(54) **MULTIPLE FUNCTION SHANK FOR A NUT DRIVER**

UNITED STATES PATENT AND TRADEMARK OFFICE
CERTIFICATE OF CORRECTION

PATENT NO. : Des. 593,823 S
APPLICATION NO. : 29/307734
DATED : June 9, 2009
INVENTOR(S) : Frank Richard Patti

Fig. 2

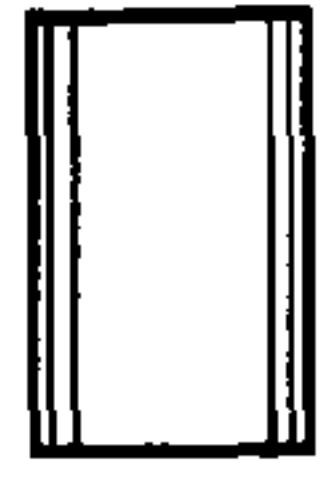
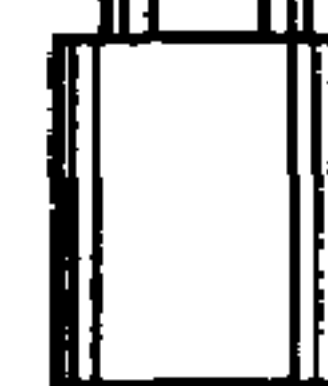
1. Specifically, on the front page of the patent, under the heading, DESCRIPTION, the word plan has been erroneously omitted from the description for Fig. 2. The sentence should read; Fig. 2 is a top plan view thereof;
2. Specifically, on page 2 of the drawing sheets, Fig. 2, Fig. 3, Fig. 4, and Fig. 5 have all been shrunk down . These Figs. are now not proportionately the same as all of the other Figs in the patent.

Fig. 11

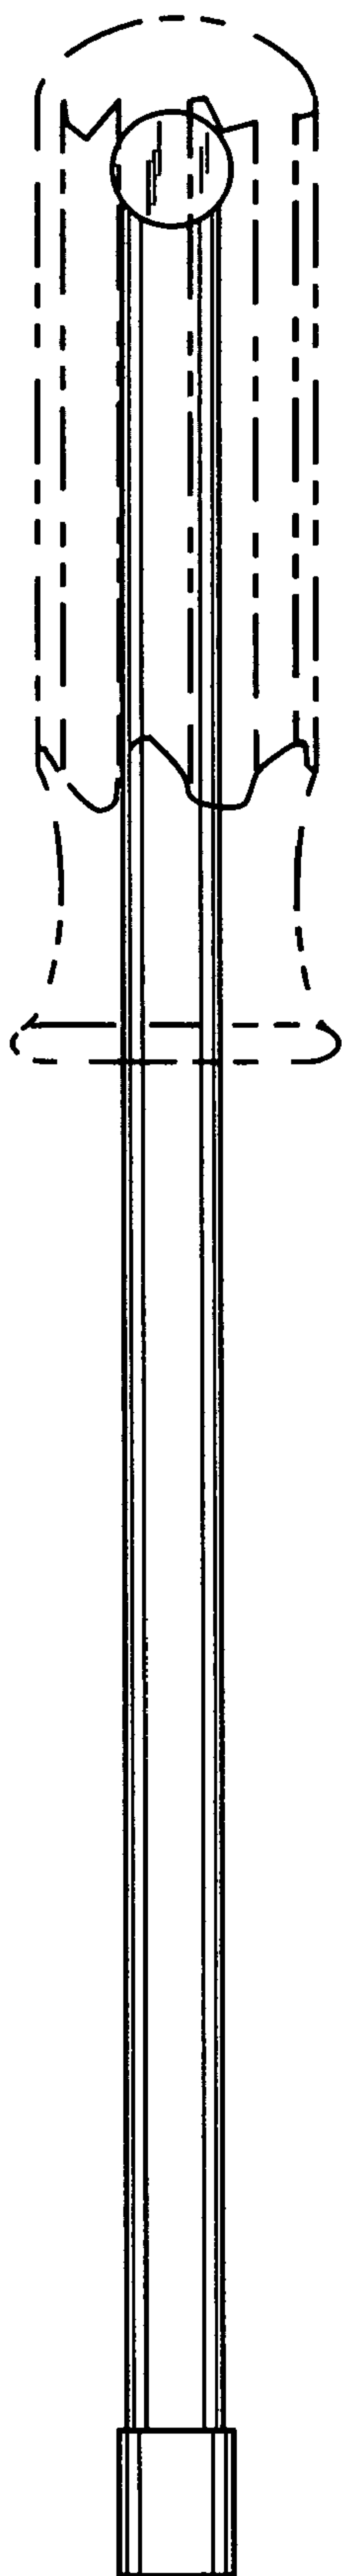
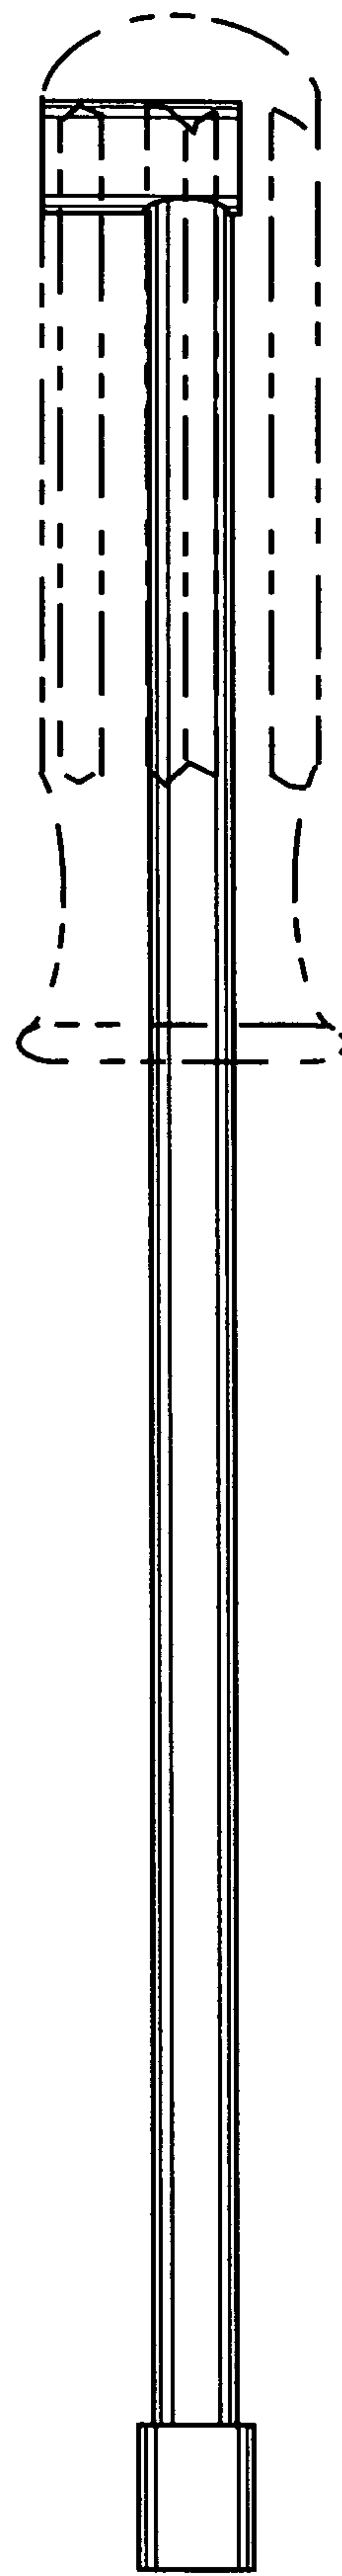
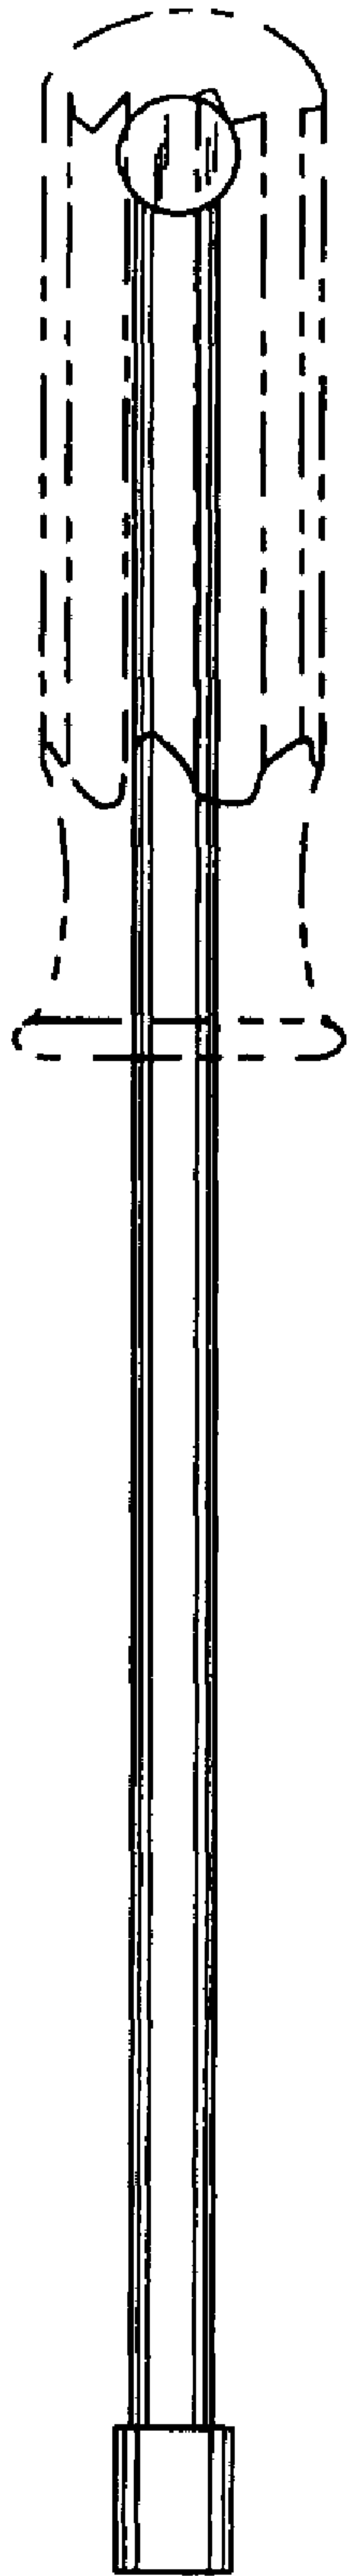
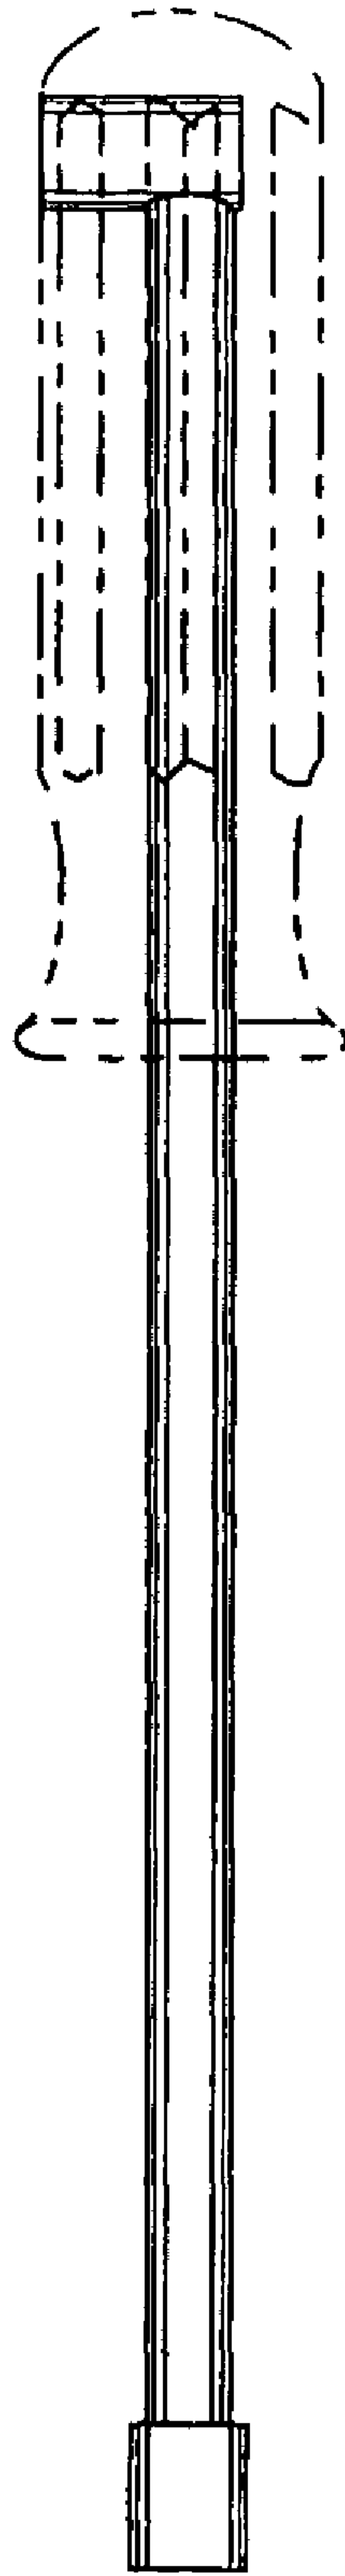
The drawing sheet, consisting of Figs. 11 and 12, should be deleted to be replaced with the drawing sheet, consisting of Figs. 11 and 12, as shown on the attached pages.
